126147 - SMART80 DASH HARNESS MY24

7057-55135-01

126147 - REV E

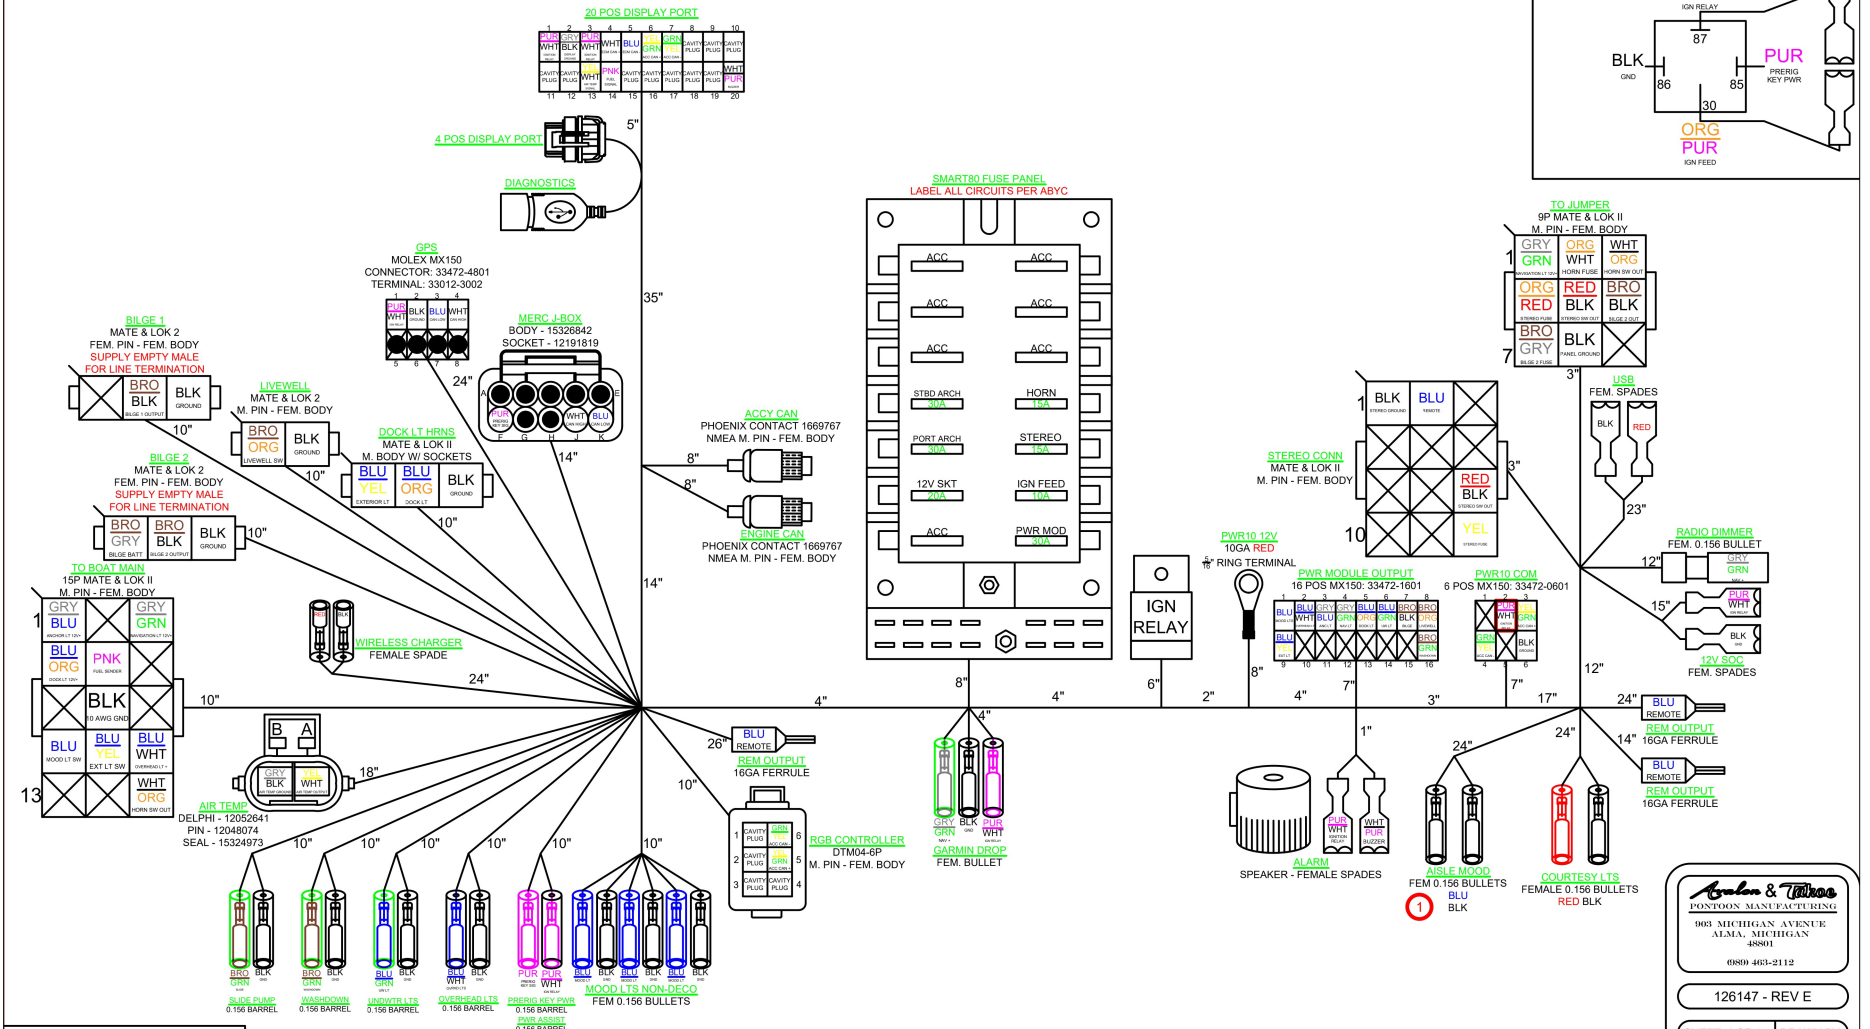
REV.	DATE	DESCRIPTION
C	8/31/23	EXTEND DISPLAY DROP BY 6"; SUBTRACT 12" FROM STEREO AND SWITCH DROP
D	9/19/23	1) CTSY LT WIRE COLOR UPDATED. 2) BOAT MAIN OV/RHD LT NAME UPDATE. 3) MOOD LT BULLETS UPDATED TO ALL FEMALE. 4) GPS, PWR ASSIST, PWR10 UPDATED TO PUR/WHT. 5) UPDATED GARMIN DROP. 6) ACC CAN UPDATED TO 8" FEM BODY. 7) ADD 12V SOC DROP
E	11/8/23	1) ADDED AISLE MOOD LIGHT DROP
